Public Comment No. 13-NFPA 54-2025 [Global Input]

Public Comment No. 23-NFPA 54-2025 [Global Input]

Figure 9.6.8.2 Method of Installing a Tee Fitting Sediment Trap.

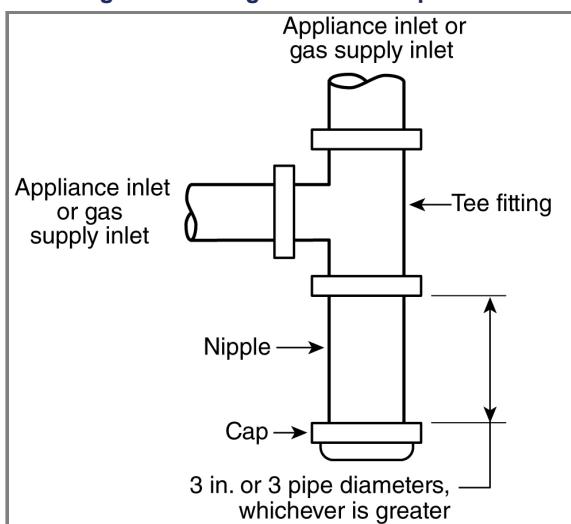
The sediment trap shall Where an appliance is served by piping 2 in. and larger a sediment trap shall be either a tee fitting with a capped nipple in the bottom outlet, as illustrated in Figure 9.6.8.2, or another device recognized as an effective sediment trap.

9.6.8.3 Appliances served by piping smaller than 2 in. shall not be required to have a sediment trap.

Revise Figure 9.6.8.2 to that published in the 2024 edition of the Code, with the text to the right of the nipple to read: 3 inches or 3 pipe diameters, whichever is greater.

The committee also revised the sediment trap requirements to allow either downward flow into the sediment trap, or horizontal flow into the sediment trap. This action ignores basic principles of physics and repeals the law of gravity. As currently require by the code, gas flows downward into the sediment trap and the flow is turned 90 degrees. Any particles, or sediment, in the gas are affected by momentum and gravity. In the current style sediment trap a particle in the gas is pulled down into the capped leg by both gravity and momentum. By allowing gas flow into the side of the tee, and then upward the contribution of momentum to gravity is lost. This style of sediment trap will always be less effective.

Resolution: Sediment traps on all gas piping are necessary to prevent debris and other material from damaging the appliance and there is no technical justification to remove them for smaller than 2" piping. The sediment trap works when gas is flowing from either direction (vertically or horizontally) as gravity still can pull the debris down once it breaks the momentum in many cases.
